Summerlin Village 21B Crystal Canyon Parcels A and B

CITY OF LAS VEGAS		DATE:
INTER-OFFICE MEMORANDUM		March 12, 2020
TO: Land Development Services Department of Building & Safety		FROM: Jennifer Shinn, P.E.  Flood Control, Engr. Associate Department of Public Works
SUBJECT:	Drainage Study for:	COPIES TO:
	Summerlin Village 21B Crystal Canyon Parcels A and B	RCI Engineering
Cross Streets:	Carriage Hill Drive and Far Hills Avenue	Woodside Homes of Nevada, LLC
File Number:	F:\Depot\DSMemos\DS05222B.doc	Bart Anderson, P.E., DevCo
Parcel Number:	137-26-212-001, 137-26-212-002	CCRFCD
Zoning Action:		
FEMA Flood Zone	YES	NO X
Proposed Storm Drain	YES X	NO

Supplement to the
**TECHNICAL DRAINAGE STUDY
FOR SUMMERLIN VILLAGE 21B
PARCELS A AND B
CRYSTAL CANYON**

RE: Crystal Canyon- Summerlin Village 21 Parcel A & B

GRADING PLANS (SHEET 4 OF 8)

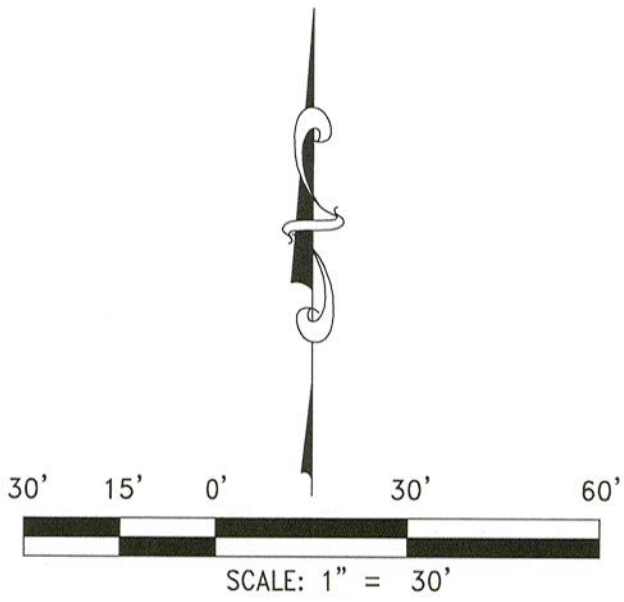
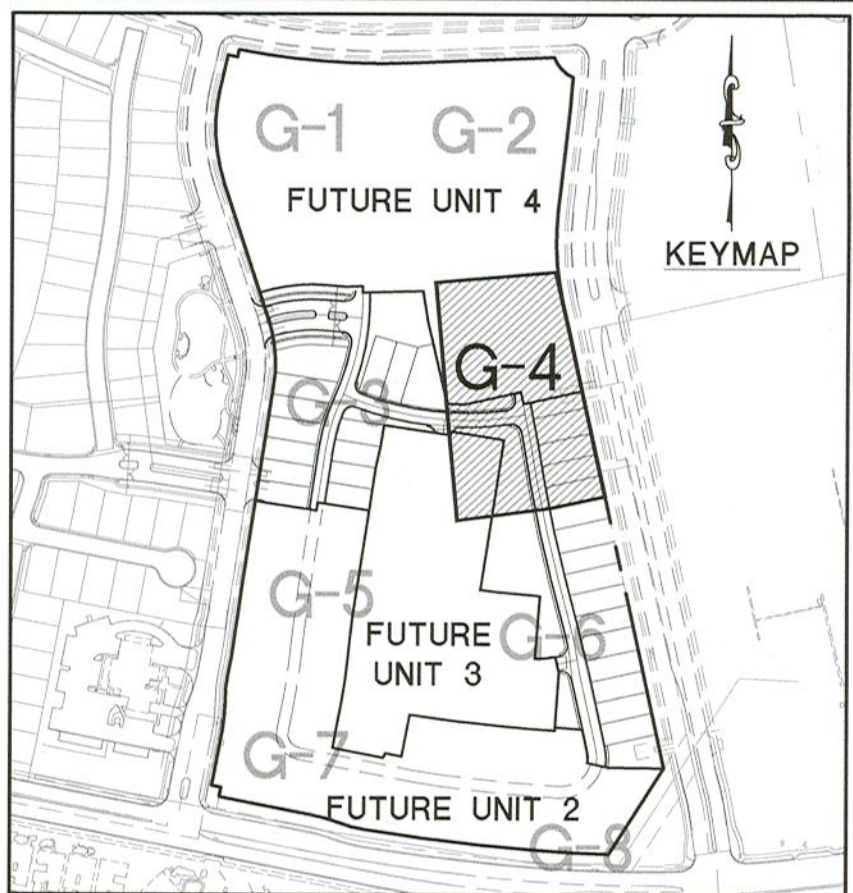
Comment 1: The maximum drop inlet length allowed in the CLV is 20'. Please revise inlet 4 to be a 20' inlet.

I finished my review of the addendum but have 1 comment that needs to be addressed before I can conditionally approve the study:
The maximum drop inlet length allowed in CLV is 20'. Please revise Inlet 4 to be a maximum of 20'. If inlets are in series, they shall be spaced a minimum of 20' apart.

Response: Drop inlet #4 has been revised to 20 feet. A revised calculation has been enclosed for that drop inlet. The calculation based on a reduced length of the inlet by 2.5 feet shows that the ponding depth at the inlet will be 0.42 feet which is still below top of curb. The previous calculation using a 22.5 foot long inlet showed a ponding depth of 0.38 and reducing the length only resulted in an increase of ponding depth of 0.04 feet. That flow is easily contained in the street and no negative impact is made by reducing that length. Sheets G-4 and P-6 from the Unit 1 improvement plans have been enclosed. Figure 6 REV was revised so that the figure shows the latest information and has been enclosed. The revised drop inlet calculation and the previous submittals calculation have also been enclosed.

- 24 CONSTRUCT #20 "CM2" DROP INLET PER CAAUSD #412.1,
- 25 CAAUSD #421, 7 GRATES
- 26 CALL BOX
- 27 CONSTRUCT #1 TYPE II-SD MANHOLE PER CAAUSD #405.2
- 28 CONSTRUCT SIDEWALK RAMP USING ARMOR TILE TRUNCATED
